Here is the main set of slides for the STP risk-informed GSI-191 meeting on 8/20/14.

Backup Slides

SSIB, Head Loss: RAI 15

ESGB, Coatings: RAI 6c

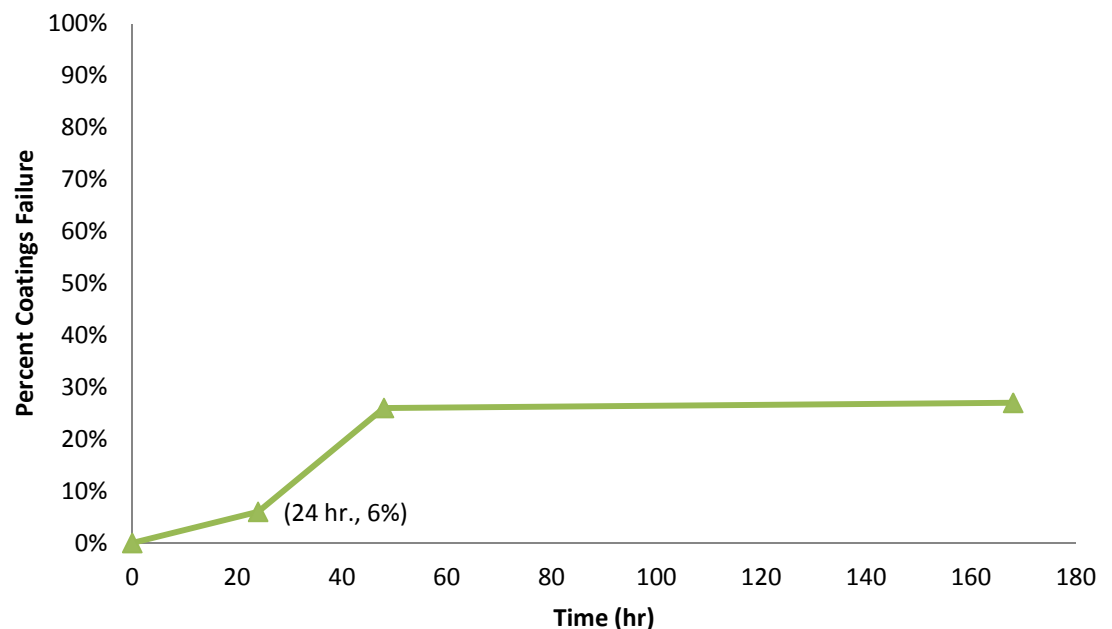
- STP seeks to reduce the failure of unqualified coatings from the deterministic methodology percentage of 100% to 6%. Provide additional justification for the current failure timing analysis.

- Alkyds have greatest influence on interpretation of filter photographs because of distinctive coloration and highest average detachment
- EPRI¹ analysis states “With regard to timing of the coating failures, the filters do not demonstrate a definitive time of failure however in subjective terms it appears that much of the failure occurred in the 24- to 48- hour timeframe”

- If “much of the failures” is 21% and the total average detachment is 27% for all coatings types 6% failure is found at 24 hours.
- Increasing the subjective amount of “much of the failures” to a higher percentage would yield a lower percentage of failed coatings at 24 hours than the STP assumed 6%.
- If subjective amount changed to 55% of available failure, the failed percentage at 24-hours doubles to 12%. Parametric evaluations have shown that risk is insensitive to this range of added particulate.

ESGB, Chemical Effects: RAI 1a

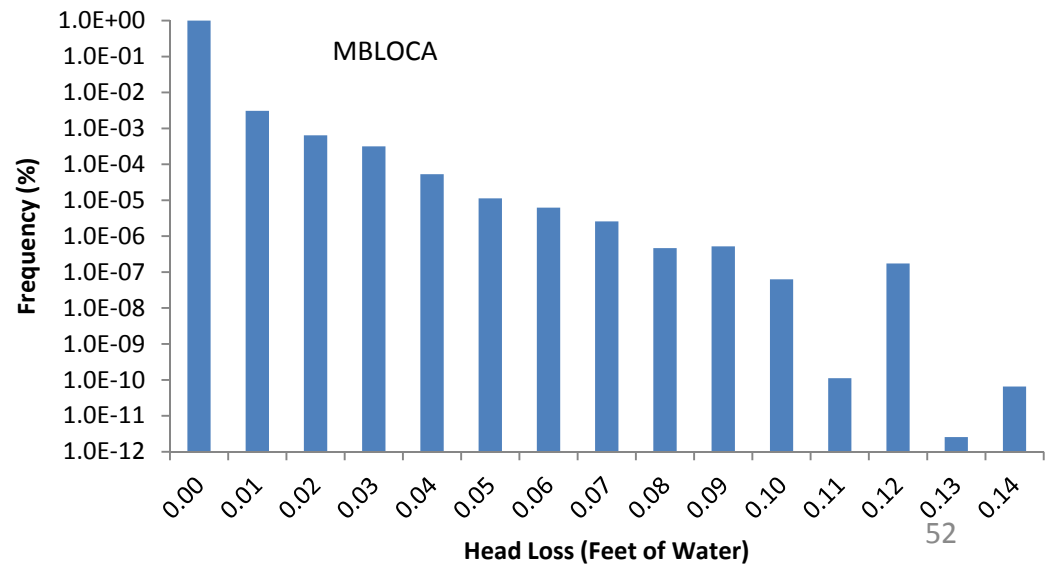
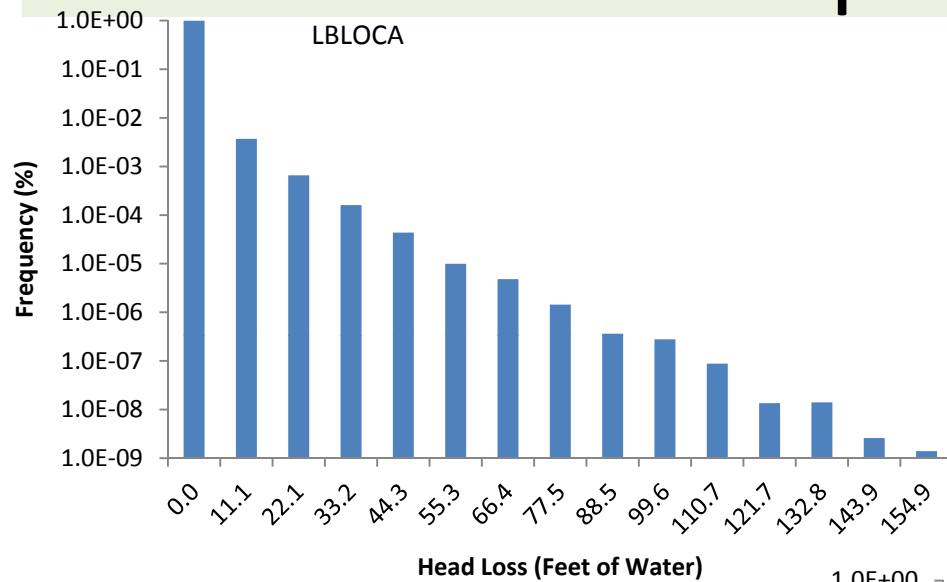
- **Please justify not correlating the chemical bump up factor to the conventional head loss since the same debris bed affects both values**

- Chemical “bump-up” factor
 - Applies maximum head loss from chemical interaction with the highest filtration debris bed
 - Based on test data (thin bed not included)
 - Conventional head loss is correlated to break size with maximum chemical interaction for increase of total head loss
 - Distributions provide opportunity for smaller breaks to have high HL
 - Simplifies the chemical and bed interaction complexity with conservatism
- Supporting calculations
 - Technical approach to support and evaluate applied “engineering judgment”
 - Allows estimation or detailed quantification of the strength and weakness of bump up approach
 - Assesses weakness of the “bump up” do not underestimate risk because of conservatisms used in generation of “bump up”

APLAB RAI 3: Justification of the Use of 25-Year Frequency Estimates

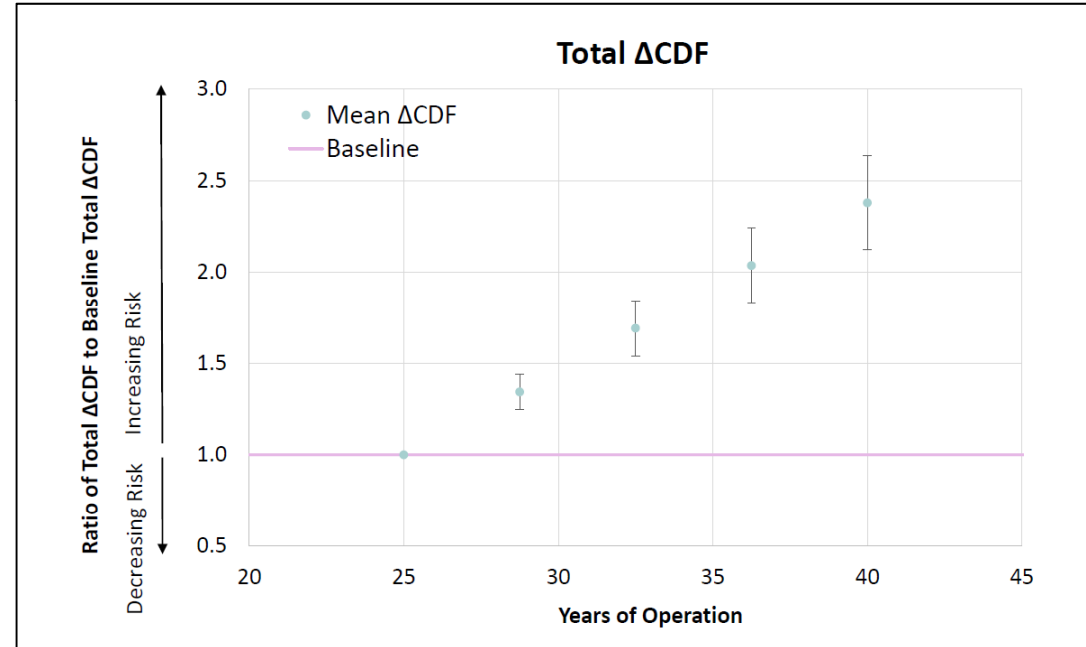
- Section 2.5.5 states that it is incumbent on the licensee to demonstrate that the choice of reasonable alternative hypotheses, adjustment factors, or modeling approximations or methods to those adopted in the PRA model would not significantly change the assessment. Also, it is assumed that the STP plants will continue to operate for more than 25 years; RG 1.174 Section 3 states that the licensee should define an implementation and monitoring program to ensure that no unexpected adverse safety degradation occurs due to the change.
 - A) Please justify the use of the 25-year frequency estimates rather than the 40-year estimates provided by NUREG-1829. Provide CDF, LERF, Δ CDF, and Δ LERF using the 40-year estimates.

- Using 40-year frequency estimates, Δ CDF increases to $6.91\text{E-}08$, a factor of about 2.4.

APLAB RAI 4A: Discrepancy Between LOCA Frequency Means for Johnson Distributions & NUREG-1829

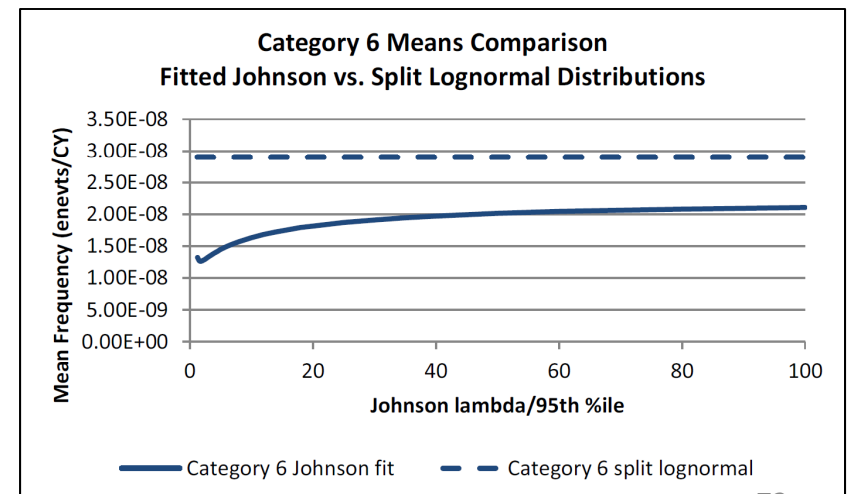
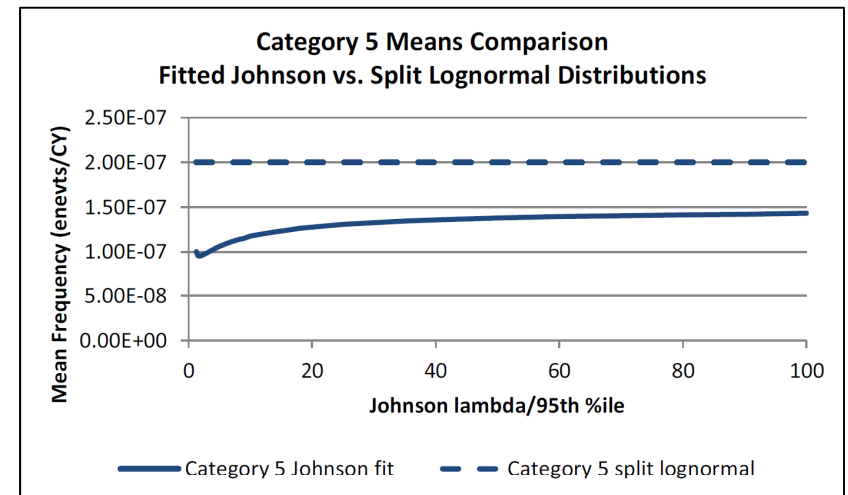
- Typically, statistical sampling simulations will develop random variables that preserve the mean of the distribution from which the variables are sampled. STP has chosen to fit a Johnson bounded distribution that matches the expert-provided 5th, 50th, and 95th percentiles in NUREG-1829, but does not match the mean values. The properties of the distribution are such that, as fit, the mean of the fitted distribution is always less than the experts' means from the distributions in NUREG-1829.

A) Please explain why the STP evaluation departs from the regulatory position in RG 1.174 regarding the use of mean values.

- Analyze means of Johnson distributions, as a function of λ .
- x-axis: Ratio of λ to elicited 95th percentile
- Means grow with λ , but level off for large values of λ
- Even at a ratio of 100, the Johnson means fall short of the NUREG-1829 means, most prominently in categories 5 and 6

APLAB RAI 4B: Explanation of the Johnson Distribution Governing LOCA Frequency

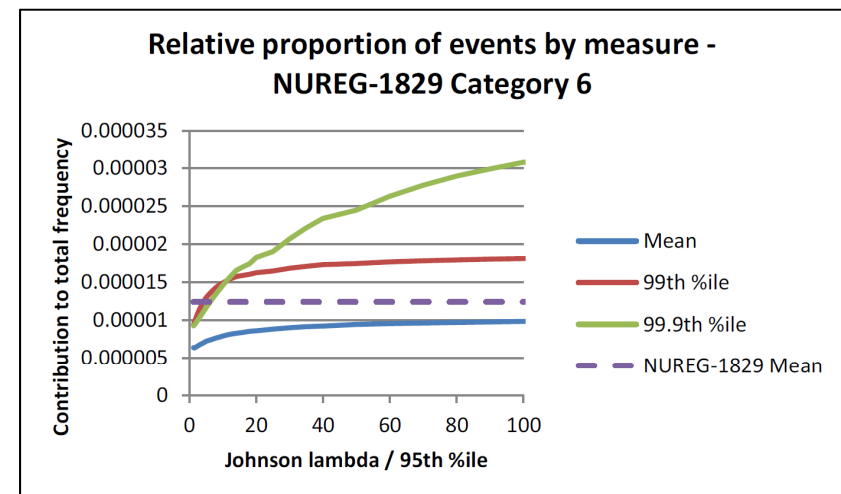
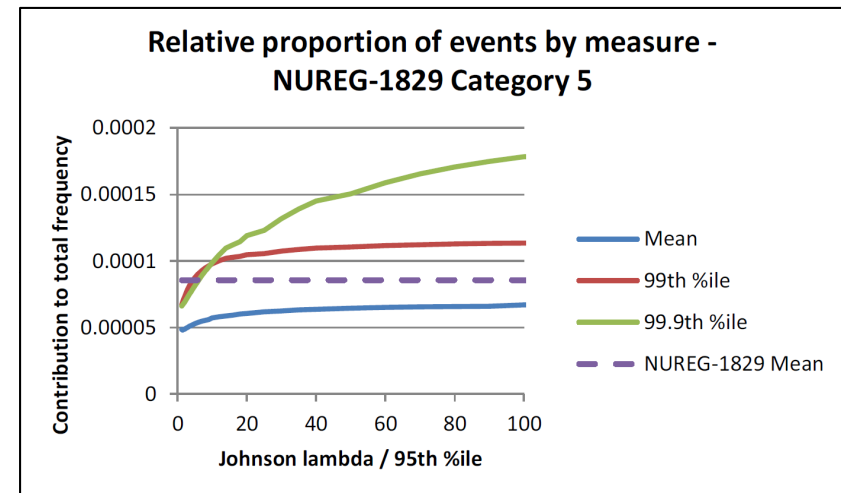
- Typically, statistical sampling simulations will develop random variables that preserve the mean of the distribution from which the variables are sampled. STP has chosen to fit a Johnson bounded distribution that matches the expert-provided 5th, 50th, and 95th percentiles in NUREG-1829, but does not match the mean values. The properties of the distribution are such that, as fit, the mean of the fitted distribution is always less than the experts' means from the distributions in NUREG-1829.

B) The Johnson fit to 5th, 50th, and 95th percentiles is not unique. Alternative accurate fits can be constructed with arbitrary values of the scale parameter λ . The scale parameter λ defines a bound on the maximal frequencies sampled in the Monte Carlo model. By increasing the value of λ , the relative proportion of large to medium to small breaks can be altered, especially in the extrapolation range beyond the 95th percentile. Please provide a technical justification for the selection of the scale parameter λ (other selections appear possible that could change the outputs by CASA Grande).

- Using the means of the Johnson distributions as metric for relative contribution of LOCA events by category:
 - Somewhat underestimate the contribution categories 5 and 6 as compared to using the implied means from NUREG-1829,
 - Overestimate the contribution of these categories versus the implied NUREG-1829 means if we use the 99th or 99.9th percentiles and a large value for λ .
- Fixing λ to twice the 95th percentile: Underestimate the contribution to categories 5 and 6, even using 99th or 99.0th percentiles, relative to NUREG-1829 means.

APLAB RAI 4C: Impact of Johnson Distribution Selection on CDF, LERF, Δ CDF, Δ LERF

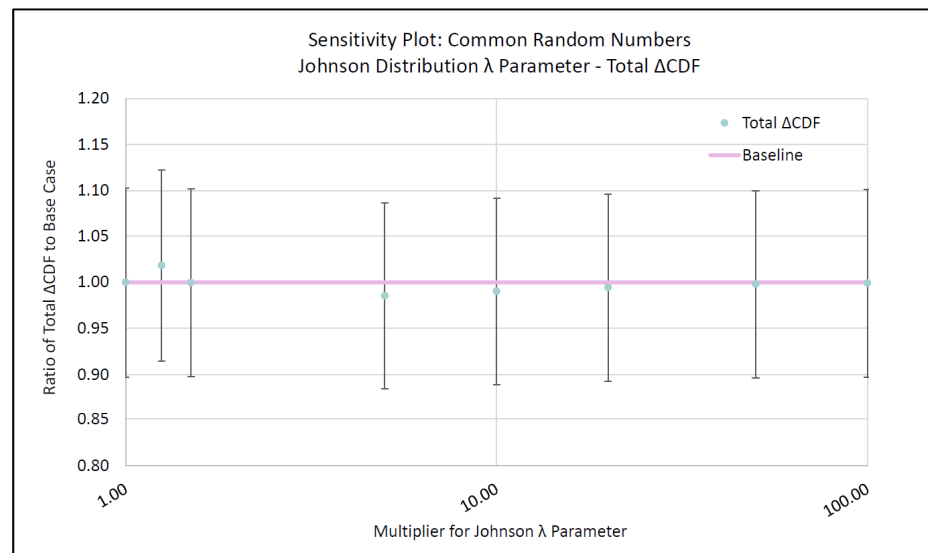
- Typically, statistical sampling simulations will develop random variables that preserve the mean of the distribution from which the variables are sampled. STP has chosen to fit a Johnson bounded distribution that matches the expert-provided 5th, 50th, and 95th percentiles in NUREG-1829, but does not match the mean values. The properties of the distribution are such that, as fit, the mean of the fitted distribution is always less than the experts' means from the distributions in NUREG-1829.

C) Please provide the maximum expected difference between the CDF, LERF, Δ CDF, and Δ LERF developed from bounded Johnson distributions that consider alternative values of the scale parameter λ , and other distributions that would preserve mean values reported in NUREG-1829. Note, in particular, that alternative bounded Johnson distributions with large values of the scale parameter λ can be built to accurately fit the NUREG-1829 5th, 50th, and 95th percentiles, and produce mean estimates closer to the NUREG-1829 values than current fits used by STP.

- Our estimates of changes in CDF, Δ CDF, LERF, and Δ LERF are modest as we range the Johnson scale parameter λ from a factor of 1.25 up to a factor of 100 times the 95th percentile of the frequencies elicited from experts in NUREG-1829. More specifically, point estimates of Δ CDF and Δ LERF increase by no more than 2% for the specific values of λ we consider here.
